Meeting Agenda Plat Committee

Monday, April 11, 2022

ITEM E1 - ALASKAN WILDWOOD EAST

KPB 2021-126
S13 T04S R14W
Nikolaevsk

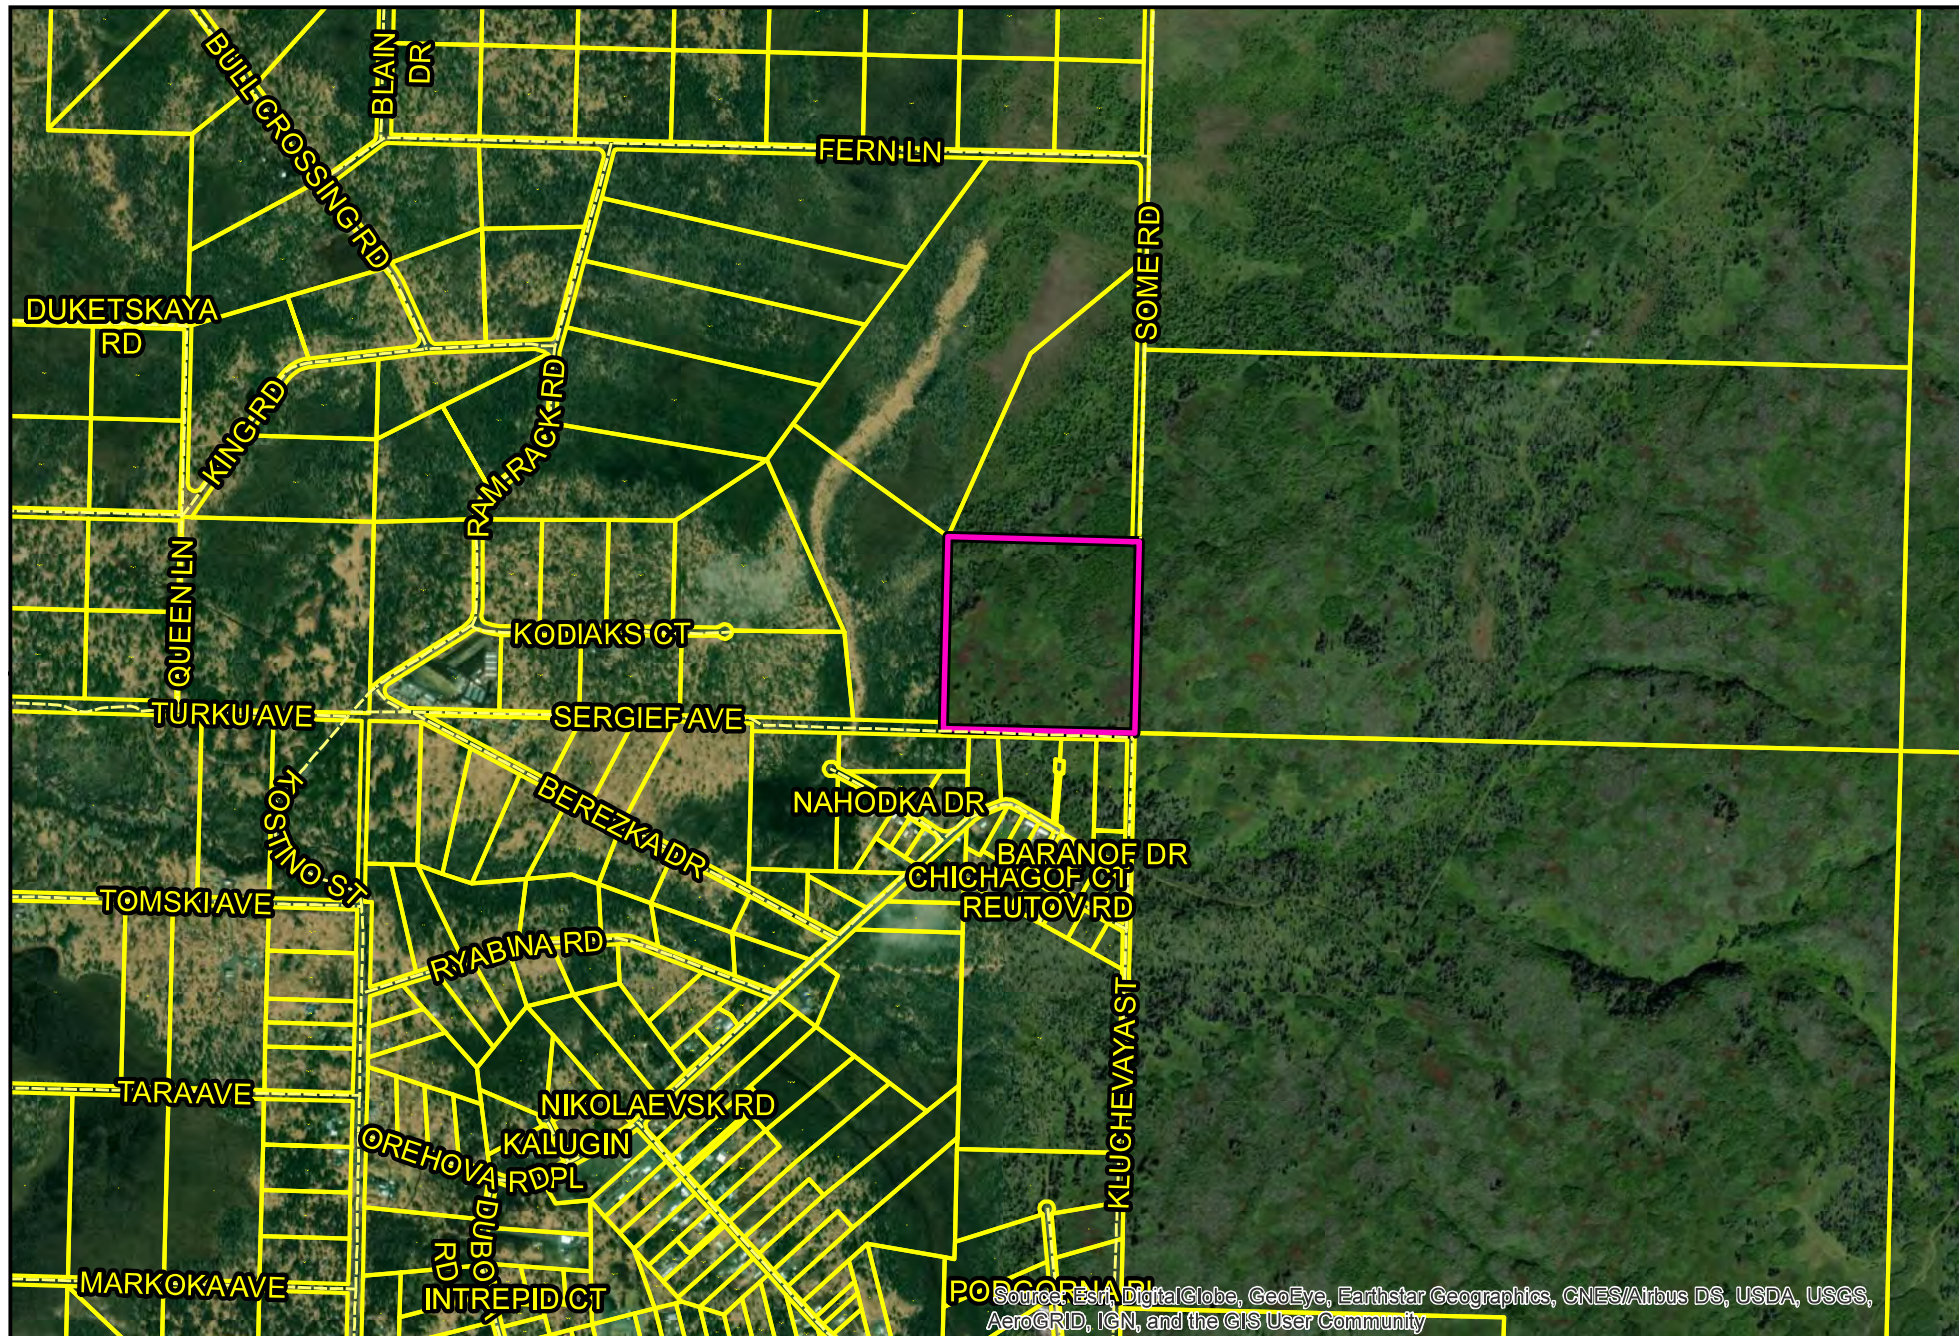
- Update the subdivision name to Alaskan Wildwood Subdivision. Phase is a designation used for a portion of a larger approved plan where portions are finalized at different times.

- Provide the KPB file number (2021-126) near or within the title block.
 - Within the title block remove the reference to Document No. 2019-002734 as that is a deed and not a document that created the parcel of land.

- Provide the owners name and mailing address within the title block.
 - Update the sheet to 1 of 1.
- C. The location, width, and name of existing or platted streets and public ways, railroad rights-of-way, and other important features such as section lines or political subdivisions or municipal corporation boundaries abutting the subdivision;

- Staff recommendation:** Label all section line easements within and abutting the subdivision such as the one within Section 19. Provide a street name label and right of way width for Kluchevaya Street.

Staff recommendation: *The hatching used on the plat is typically used to depict vacations. No hatching is required for ROW dedications. Provide labels that state ROW being dedicated this plat. Update to the subdivision boundary to show the parent parcel as the boundary.*

Staff recommendation: *Provide a minimum 30 foot dedication along the eastern boundary for the extension of Some Road.*

Staff recommendation: *Within the drawing, depict and label the 20 foot building setback.*

Plat note 1 is duplicated within plat note 3. Remove plat note 1 or remove that portion from plat note 3.

Plat note 6 refers to a registered trademark. Staff is unsure as to the intent for this note, as there does not appear to be any reference outside of the plat note to Alaska Wildwood Ranch. Remove plat note 6 from the final plat.

Staff recommendation: *Provide all survey marker cap information for found monuments. Comply with 20.60.200*

ROAD PLAN AND PROFILE OF

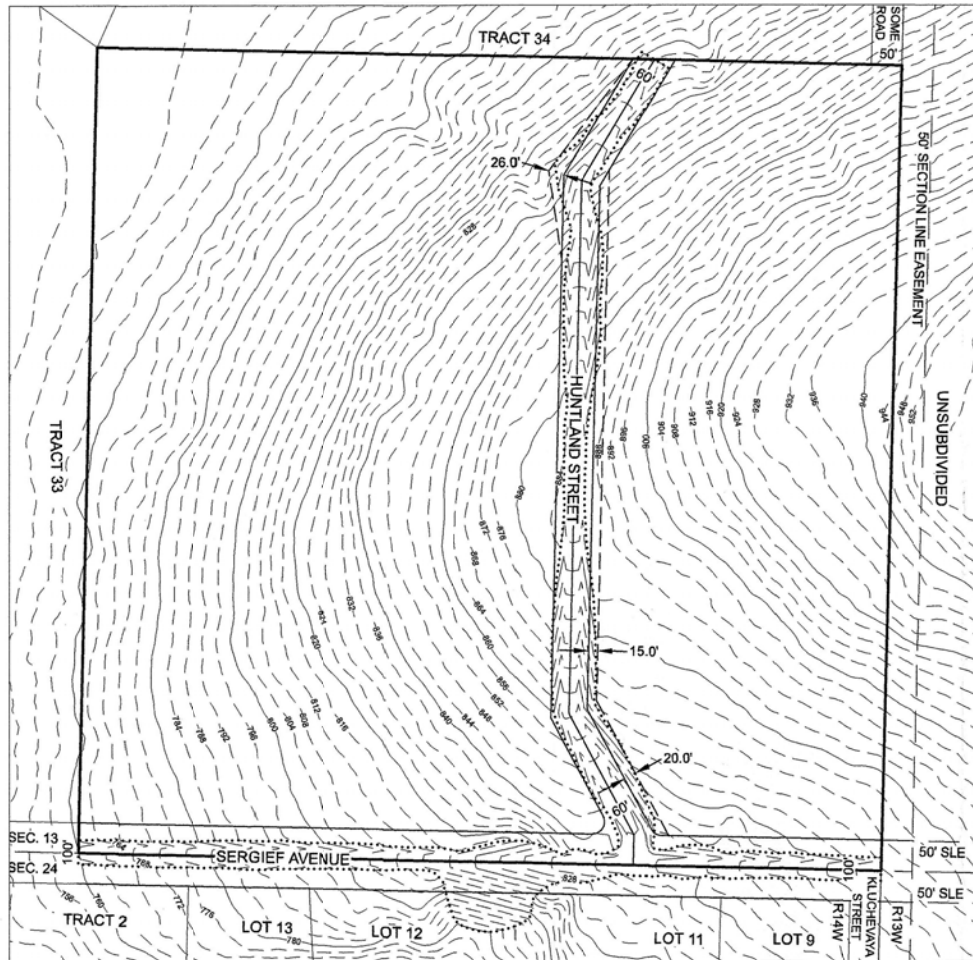
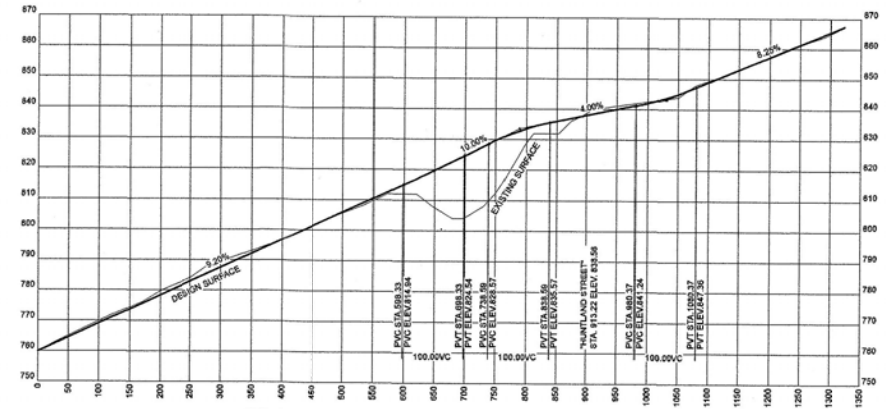
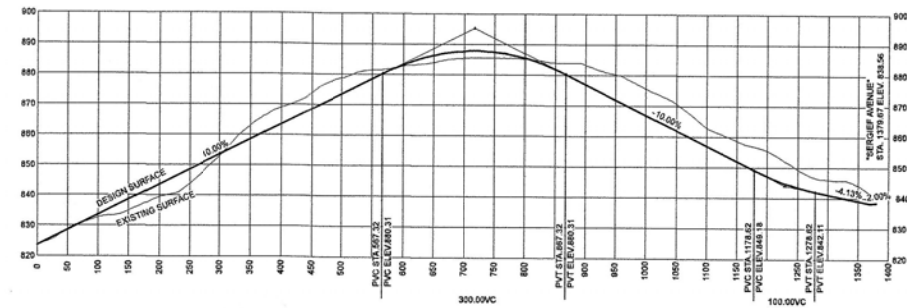
Staff recommendation: *If necessary, provide lateral support (slope) easements for any roadways that are affected by steep terrain so that a road way can be constructed with no more than a 10% grade. Provide road plans with centerline profiles and cross sections to show the roadway limits.*

Staff recommendation: *Provide road plans with centerline profiles and cross sections to show the roadway limits.*

KPB 20.30.190 – Lots Dimensions

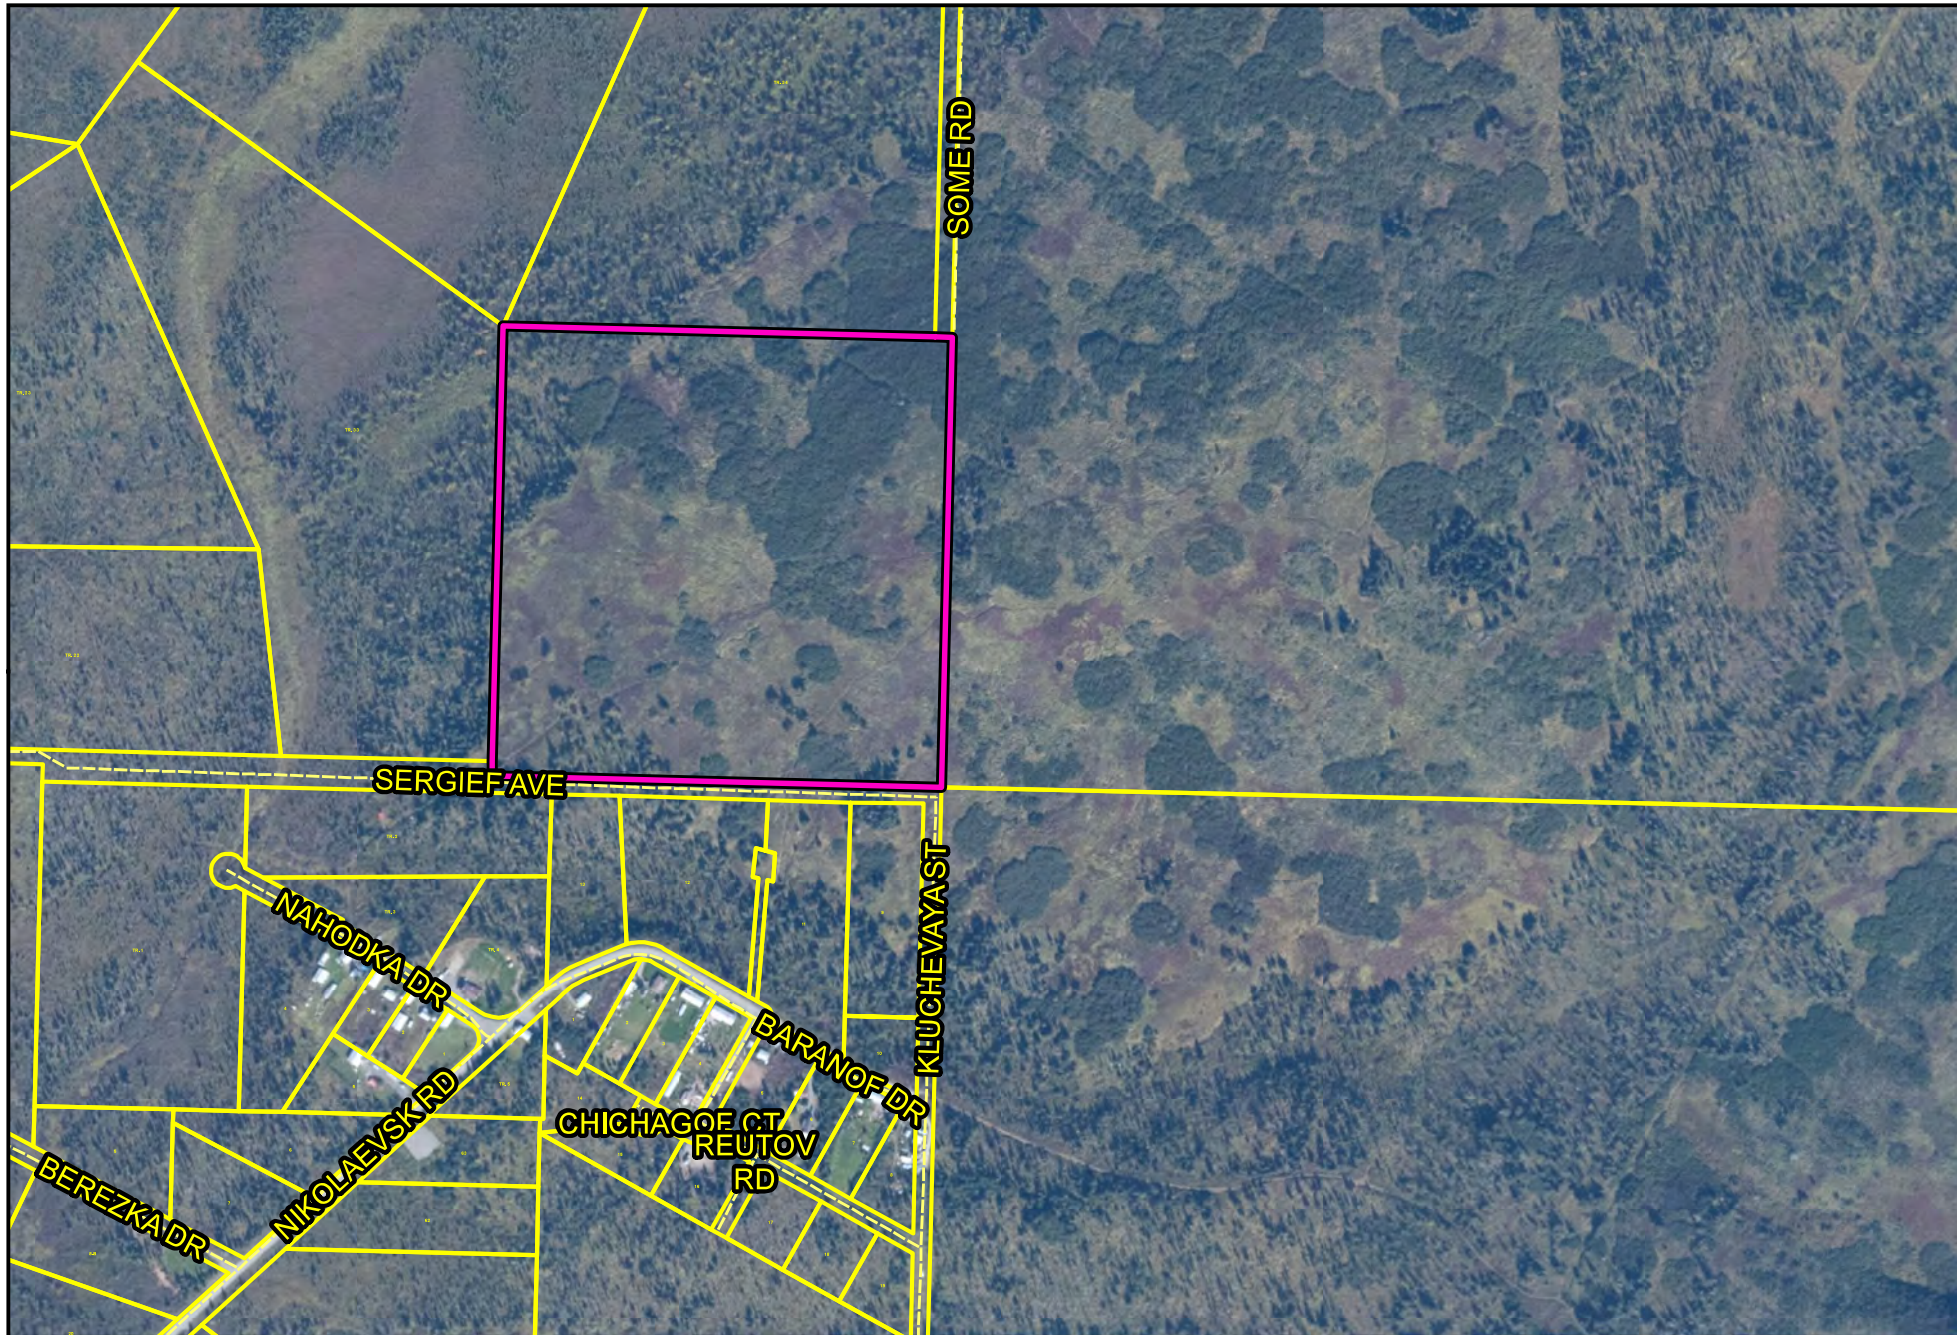
The original design, approved by the Plat Committee, was going to subdivide a 40 acre parcel into eight lots and provide a right of way dedication. This plat is being brought back to the plat committee as the surveyor has requested an exception to KPB 20.30.190 – lots dimensions, 3:1 depth to width ratio for Lot 4.

Staff Discussion: The Kenai Peninsula Borough Plat Committee heard and approved the preliminary plat at the September 27, 2021 meeting. A final was received for review on November 8, 2021 with the same design. Due to the terrain, centerline profiles were requested to determine if slope easements would be required. The surveyor determined, due to the terrain, the road needed to be slightly adjusted. The final submitted on February 22, 2022 showed a minor design change. There are still eight lots but the configuration and the road design have slightly changed. The design is keeping the lots above 200,000 square feet so that soils analysis report is not required. The new design has resulted in one of the lots not complying with the 3:1 depth to width requirements.

5. KPB Code requires a ratio of 3:1 for the depth to width of lots.
6. Due to the change in design, the ratio for Lot 4 is 3.3:1.
7. There are some low wet lands present in the western portion of Lot 4.
8. The change in design can be attributed to the terrain and the need to place the right of way dedication in the best location.
9. The road has been shifted to the east to provide a better connection to Sergief Avenue.
10. Slope easements are proposed and have been reviewed and approved by the KPB Roads Department.
11. The redesign changed from four lots on each side of the dedication to five on one side and three on the other.

An exception is requested to the borough code requiring that the average depth of a lot shall be no greater than three times the average width. This request is for Lot 4 of the proposed subdivision.

Staff recommendation: place notes on the final plat indicating any exceptions granted by the Plat Committee with the meeting date and provide the correct Wastewater Disposal note.
